Drum flange bolt torque specification inspection

Date: May 03, 2022
Bulletin Name: MXR-TSIB-035
Model: Bridgemaster (93) and Standard (90) Mixer
Model Year: 2021 and 2022
Units Affected: Units delivered to customer between 03/01/2021 and 02/28/2022

Inspection and possible rework required on drum flange bolt torquing specifications on certain Rear Discharge Mixer vehicles.

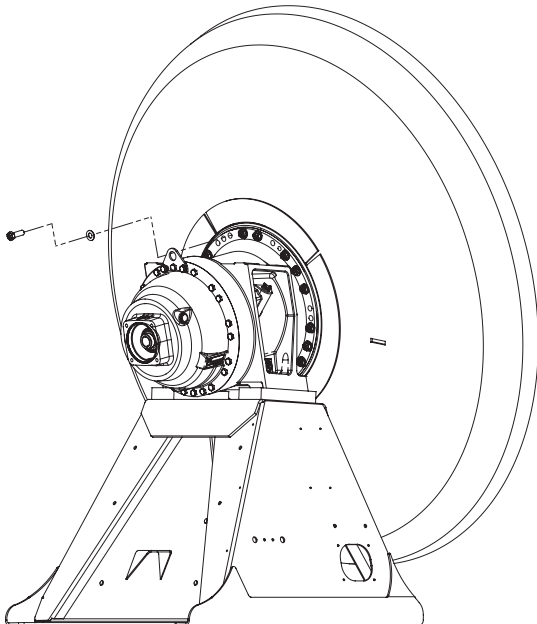
1. Perform your company's Lockout/Tagout procedure. If your company does not have a Lockout/Tagout procedure, follow OSHA 1910.147 and 1910.146 Confined Space as appropriate.
2. Check the torque on all 18 drum flange bolts. If a bolt turns during this check, then all bolts and washers, regardless if they do not turn, must be removed and replaced with new bolts (PN 1470296) and washers (PN 0100565).

3. Clean the bolt threads.
4. Install the bolt(s) and washer(s) and tighten to 212 ft.-lbs. using a torque wrench.

5. Mark each bolt with the marker (or paint pen or tamper-proof paste) to signify that bolt has been torqued.
6. Procedure is complete. Remove your company's Lockout/Tagout procedure. If your company does not have a Lockout/Tagout procedure, follow OSHA 1910.147 and 1910.146 Confined Space as appropriate.
7. Return truck to service.
